Access Compliance Report

Public Rights-of-Way

Intersection ID: 28411	Main Street: CHASTAIN_WALK_DR	Cross Street: LONG_RUN_LN	Location: NW
ADA ID: E6CE8409DCB3	Ramp Type: Perp	Initial Pass/Fail: Fail	Overall Compliance: No
			Severity Score: 13.75

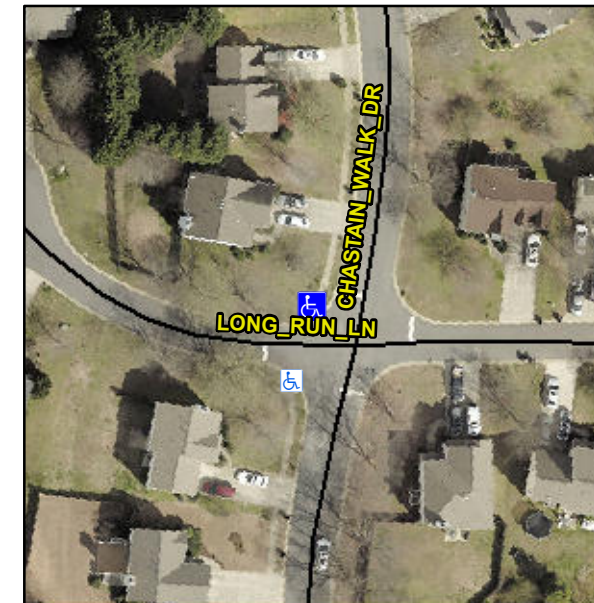
Not Found, R304.2.2, R304.5.3

Compliance	Description	Data	Compliance	Description	Data
N/A	Ramp Length (in)	46.0	No	Ramp Slope (%)	11.8
Yes	Ramp Width (in)	52.0	No	Ramp XSlope (%)	3.6
N/A	Flare Type LT	N/A	N/A	Flare Type RT	N/A
N/A	Flare Slope LT (%)	N/A	N/A	Flare Slope RT (%)	N/A
N/A	Flare Traversable LT?	N/A	N/A	Flare Traversable RT?	N/A
N/A	Landing Length (in)	N/A	N/A	DWS Provided?	N/A
N/A	Landing Width (in)	N/A	N/A	DWS Contrast?	N/A
N/A	Landing Slope (%)	N/A	N/A	DWS Length (in)	N/A
N/A	Landing X Slope (%)	N/A	N/A	DWS Full Width?	N/A
N/A	Landing Curb? (Y/N)	N/A	N/A	DWS Offset (in)	N/A
N/A	Shared Landing?	N/A			
N/A	Gutter Ponding?	N/A	N/A	Gutter Slope (%)	N/A
N/A	Gutter Lip Ht (in)	N/A	N/A	Gutter X Slope (%)	N/A
N/A	Painted X Walk1?	No	N/A	Painted X Walk2?	N/A
	X Walk 1 Direction	To SW		X Walk 2 Direction	N/A
N/A	X Walk 1 Width (in)	N/A	N/A	X Walk 2 Width (in)	N/A
	X Walk 1 Slope (%)	5.6		X Walk 2 Slope (%)	N/A
	X Walk 1 X Slope (%)	2.1		X Walk 2 X Slope (%)	N/A

Remove & Replace Entire Ramp.
